Inland Transport Committee

Working Party on Noise

Report of the Working Party on Noise on its seventieth session

Adopted amendments to UN Regulation No. 51 (based on ECE/TRANS/WP.29/GRBP/2019/13 and GRBP-70-26-Rev.1)

"Figure 3a

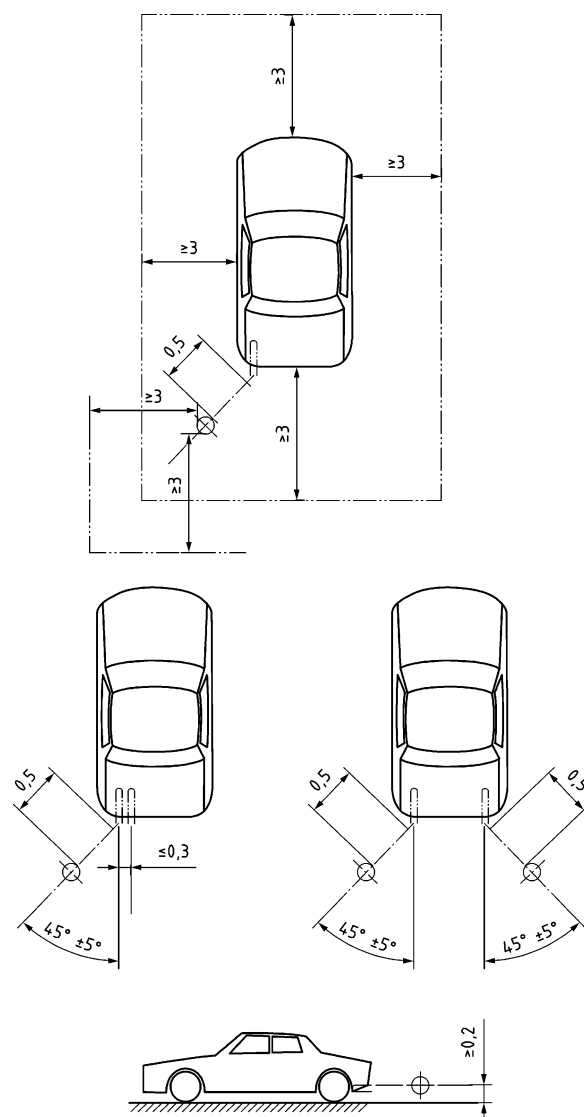
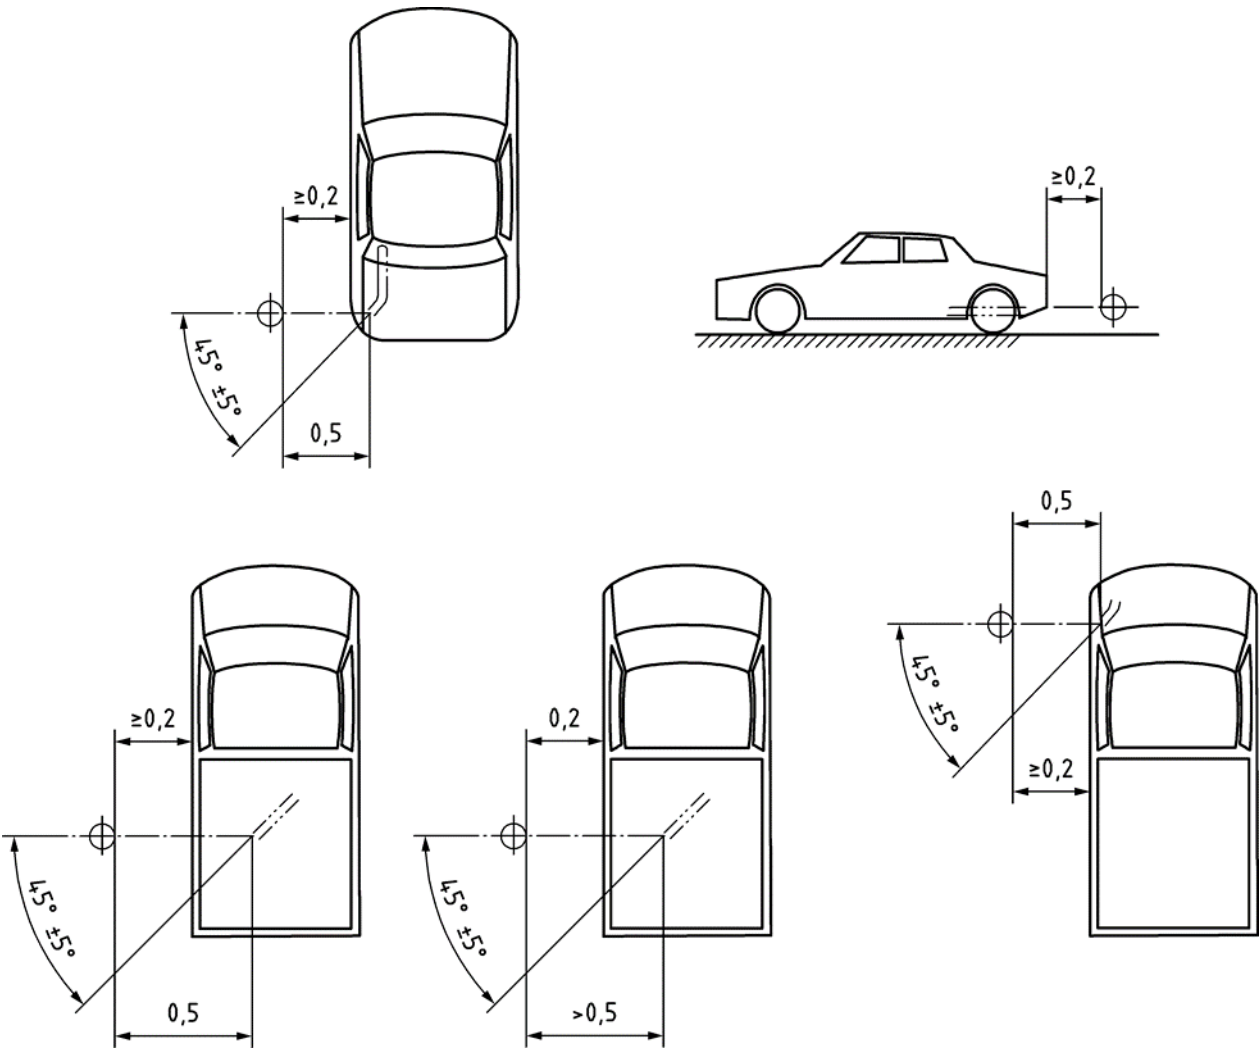
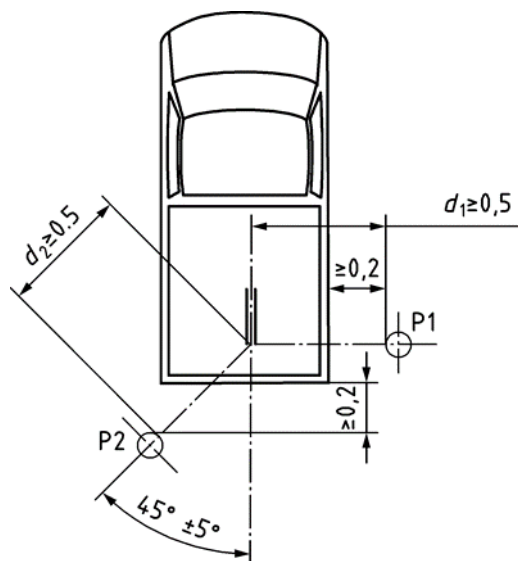
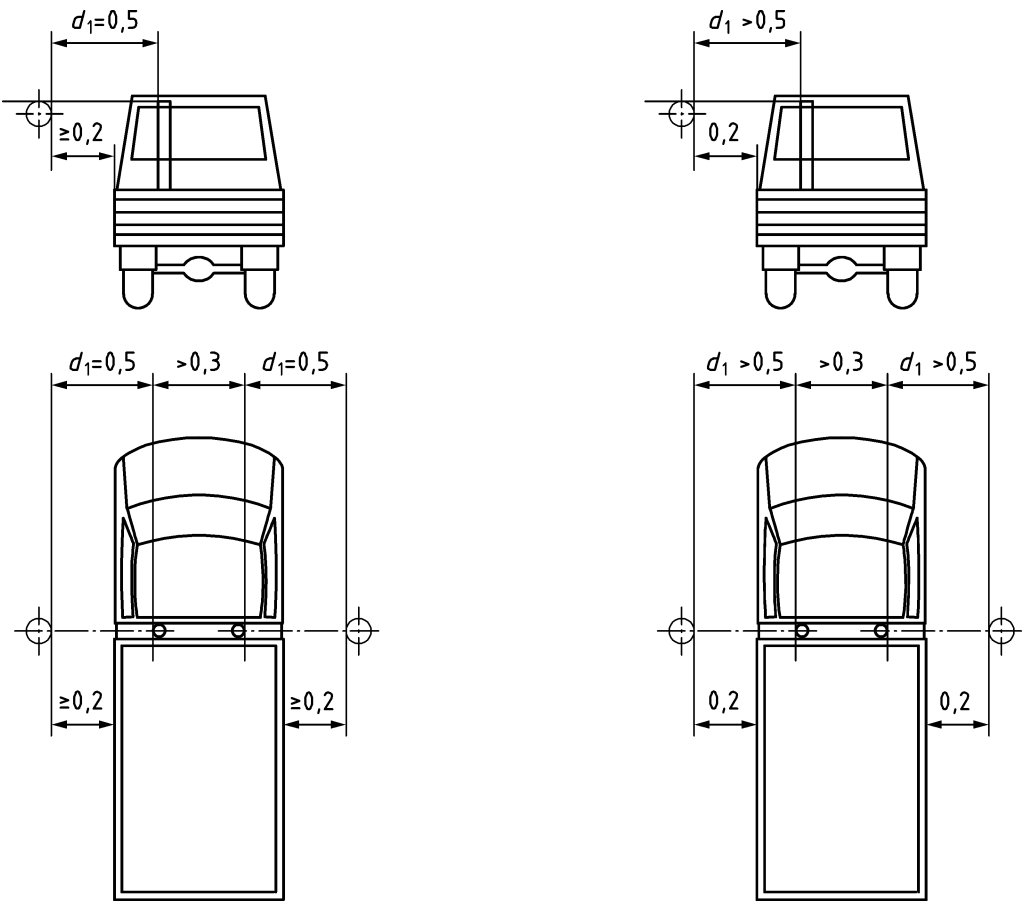
For vehicles, where the reference point of the exhaust pipe is not accessible, or located under the vehicle body, as shown in Figure 3b and 3c in Annex 3, because of the presence of obstacles which form part of the vehicle (e.g. spare wheel, fuel tank, battery compartment), the microphone shall be located at least 0.2 m from the nearest obstacle, including the vehicle body, and shall not be located under the vehicle. Its axis of maximum sensitivity shall face the exhaust outlet from the position least concealed by the above mentioned obstacles. In case the distance from the exhaust outlet to the other side of the vehicle is larger than 0.2 m (Figures 3c and 3d in Annex 3), the following distances of d_1 and d_2 shall be chosen:

When several positions are possible, as shown in Figure 3c, the microphone position giving the lowest value of d_1 or d_2 shall be used."

Annex 3 – Appendix, amend to read:

Flowchart for vehicles tested according to paragraph 3.1.2.1. of Annex 3 to this Regulation – ~~L_{urban}~~ L_{urban} computation

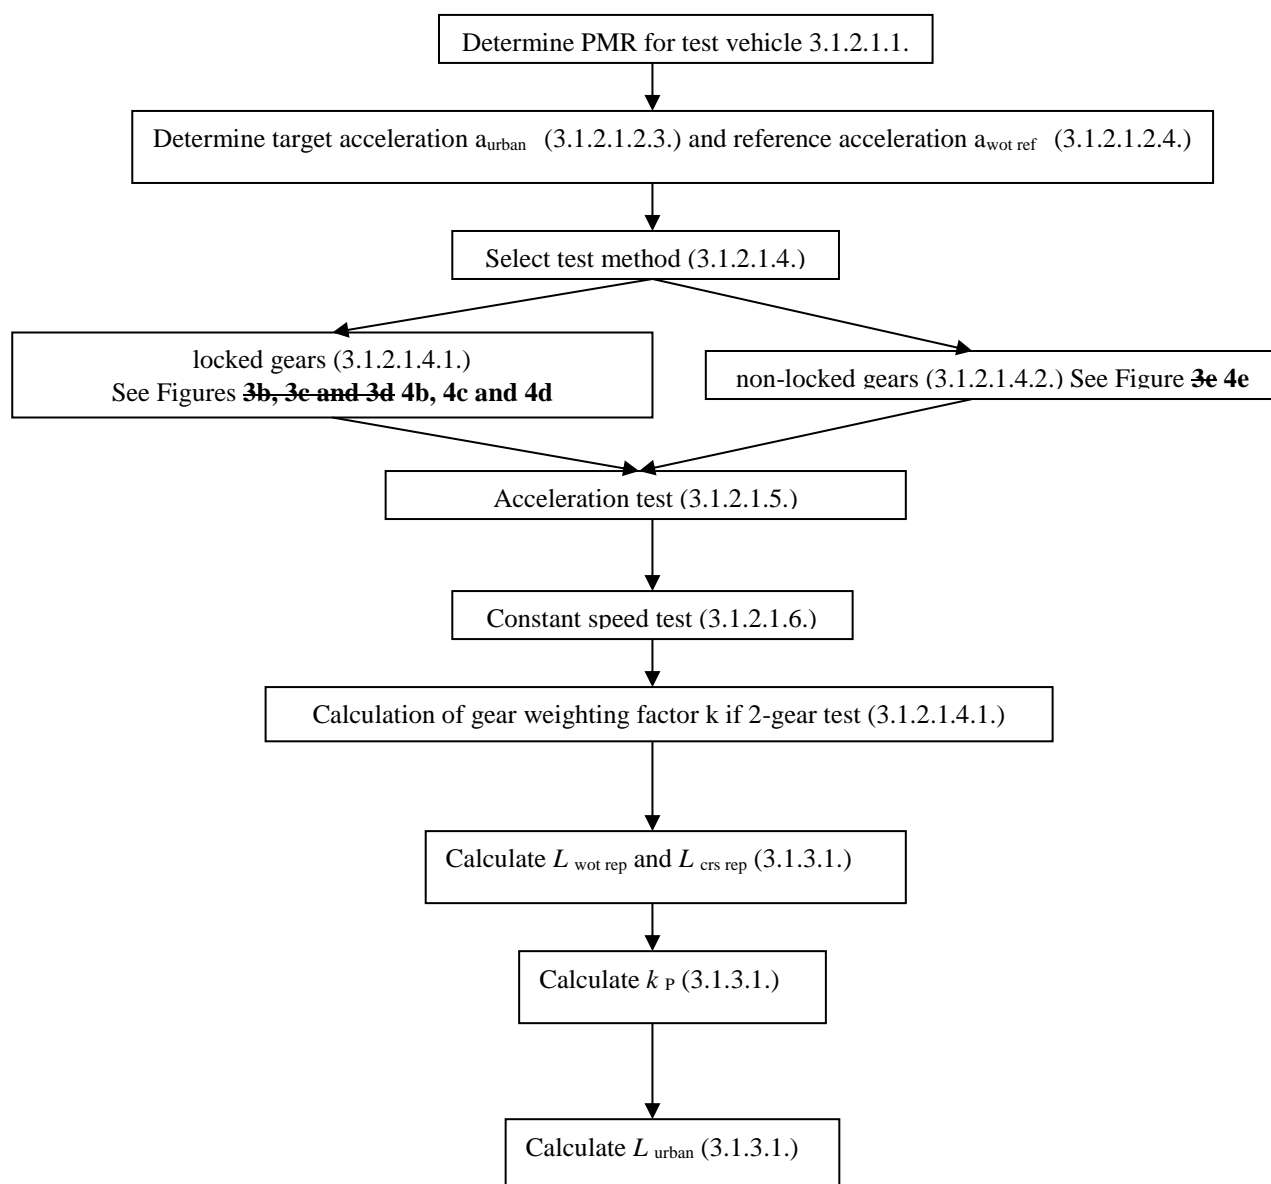
Figure 4a, amend to read

Flowchart for vehicles tested according to paragraph 3.1.2.1. of Annex 3 to this Regulation - Gear selection using locked gear. PART 1

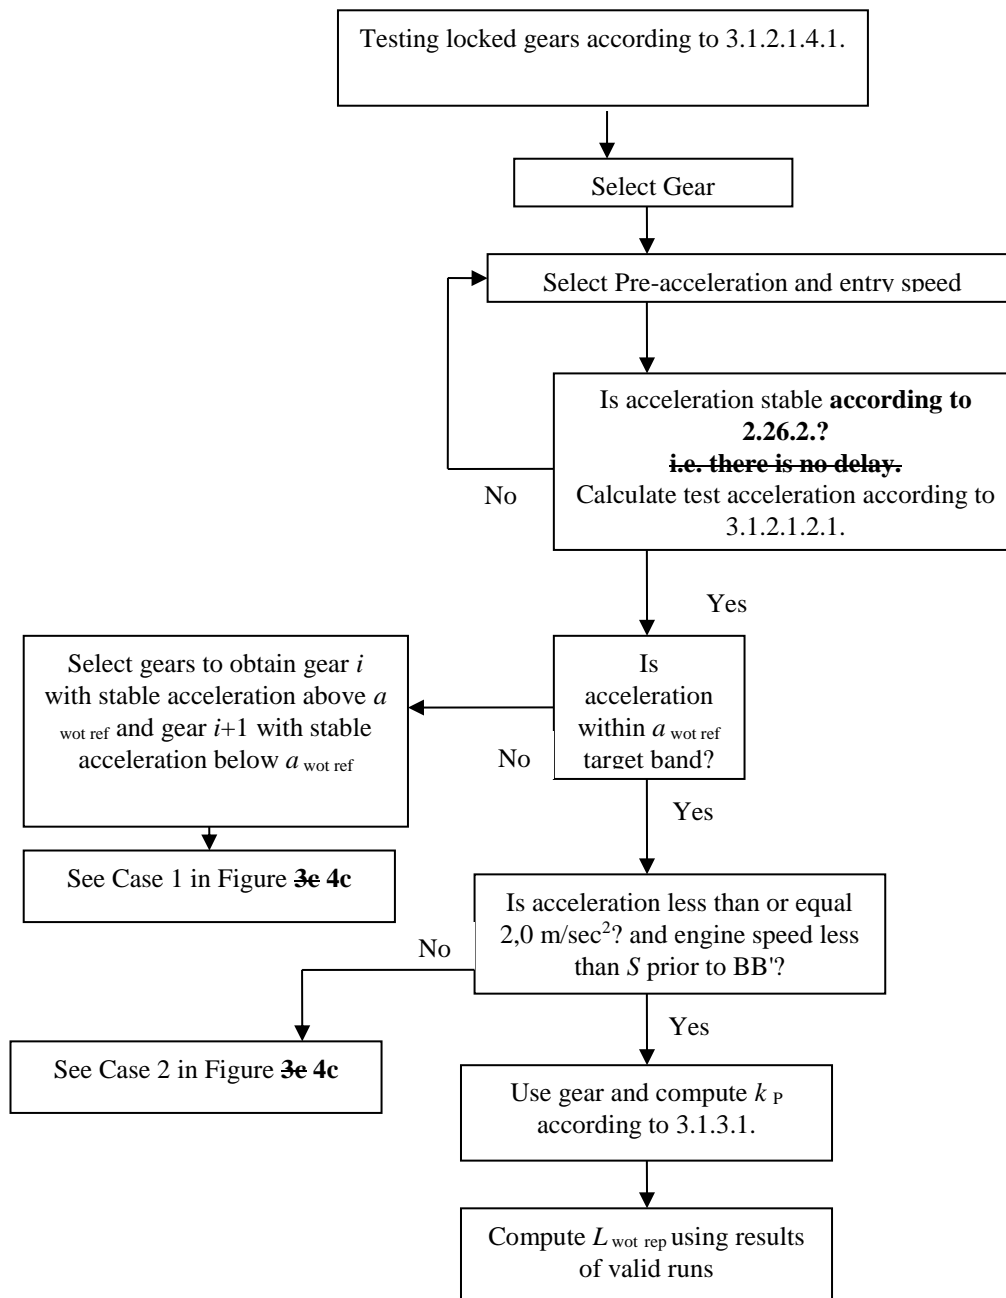
Figure 4b, amend to read:

Flowchart for measurement and data processing of stationary sound according to paragraph 3.2.

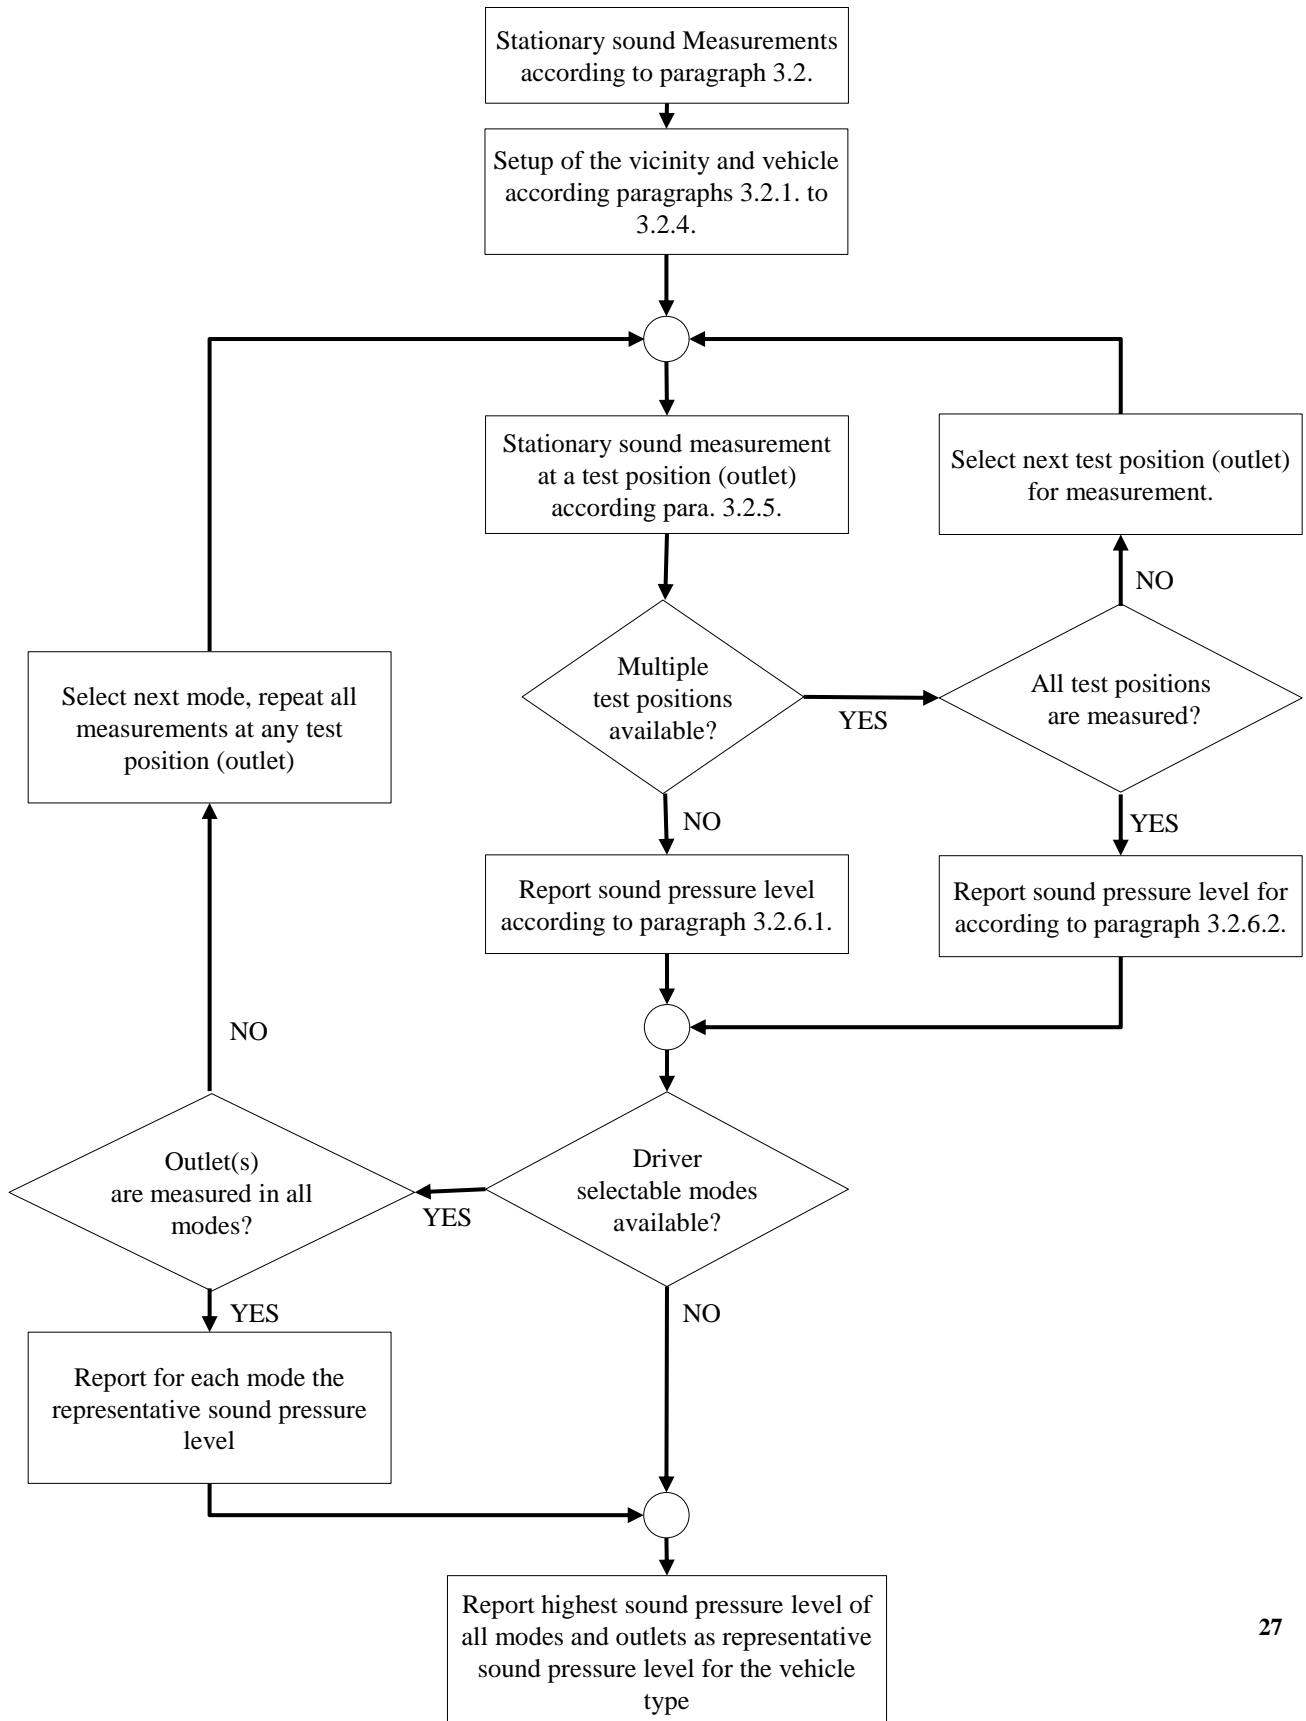
Add a new figure 6:
